HABRO

Sketch mark up.

SKT-0209798-7C-MH-20211116-Indic ative Service Routes for Planning

Third Floor

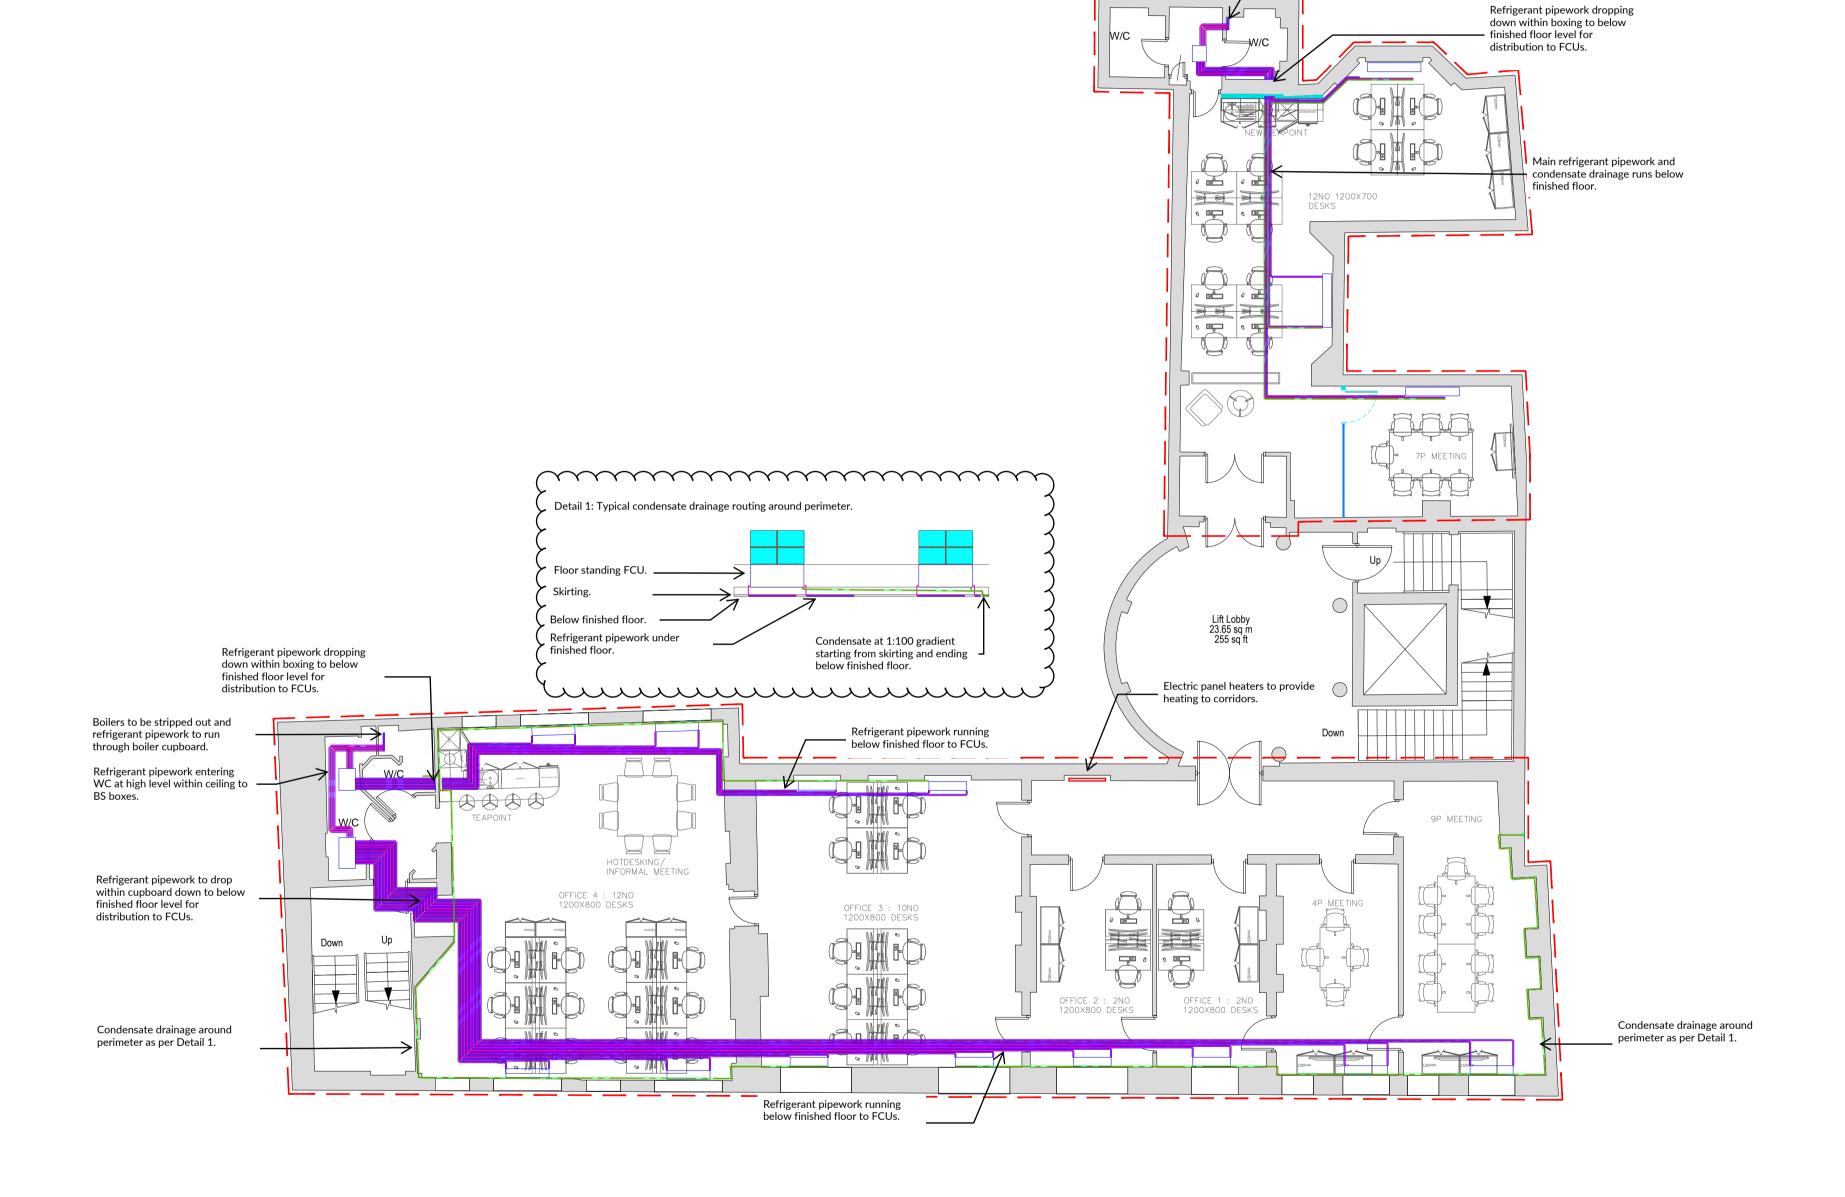
Refrigerant pipework entering WC at high level within ceiling to — BS boxes. Boxing in required to conceal pipework dropping to

First Floor

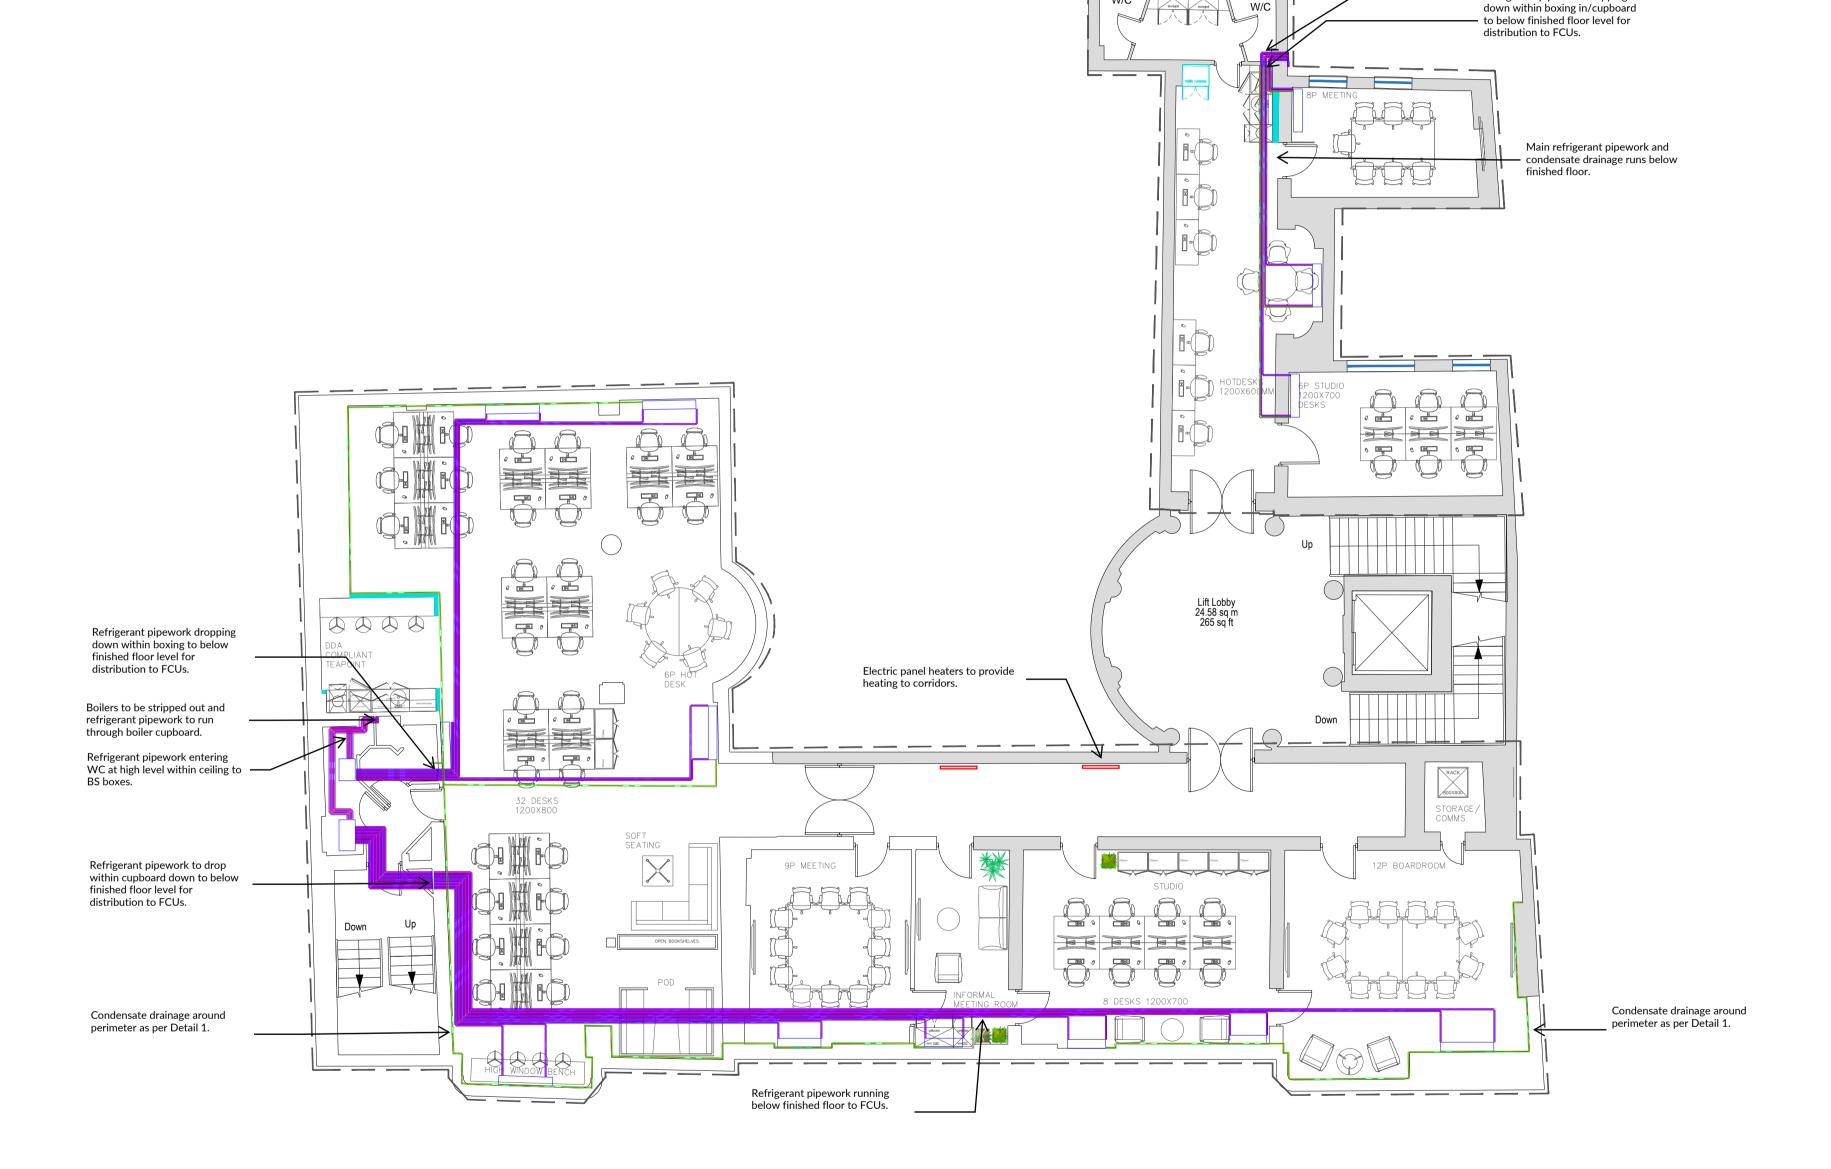
Refrigerant pipework entering WC at high level within ceiling.

Refrigerant pipework dropping
